Report to Planning and Environment Committee

Subject: 1453-1459 Oxford Street East & 648-656 Ayreswood Avenue

Public Participation Meeting

Date: November 22, 2021

Figure 5: Site concept plan (amended proposal)

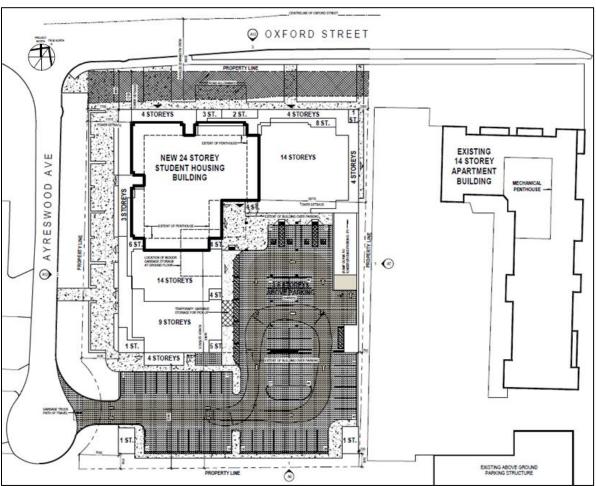
The middle of the proposed building consists of varying heights from 9 to 14 storeys at the rear, 14 storeys on the east side and along the Oxford Street East frontage, and a 24 storey tower positioned at the corner. While the varying heights provide some transition from adjacent properties, it also results in a heavy slab-like building mass that imposes on both street frontages and the surrounding neighbourhood. Building elevations are provided in Appendix B.

The site is located across from a major pedestrian destination point (Fanshawe College). The base of the building has made an effort to provide a pedestrian-scale environment, however Urban Design staff recommend greater tower setbacks from the edge of the podium be provided to assist in minimizing the building mass from the street level. Enhanced sidewalks and patio areas are provided along both street frontages to provide ground-level amenity areas. However, the proposed building coverage and amount of hardscaping results in limited opportunity for landscaping at grade.

Of greatest concern are the reduced interior side yard depths, as the proposed 1.7 metre setback leaves little opportunity for plantings and vegetative buffers, and continues to reduce as the side lot line tapers towards the rear of the site. The building is set back 0.9 metres at its closest point to the side lot line, which lends no opportunity for plantings and provides very little separation from the adjacent property. It should be noted that this reduced setback has not been captured in the revised application and would need to be addressed should Council approve the requested amendments. These narrow side yards also lead to Stormwater issues as it limits the available space for landscaping to help deal with stormwater runoff.

October 15, 2021: Site Plan

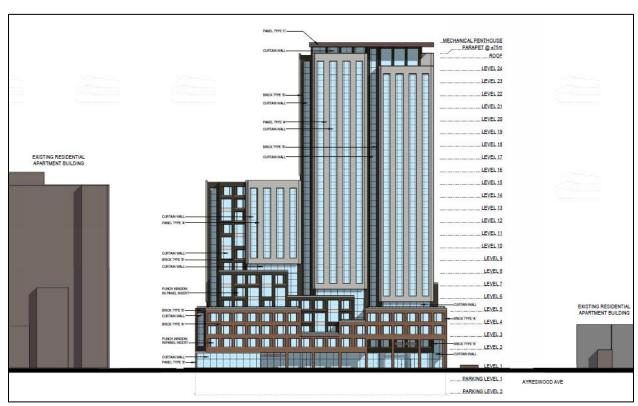
Based on the latest submission for special provisions and the provide SP I can offer the following comment:

The reduced setbacks requested for interior and rear yard, in addition the reduce landscaped open space do not allow for the required perimeter plantings under the Site Plan Control By-law. This is a concern both from a policy perspective (stated goals of tree canopy) and function (quality living environment for future residents).
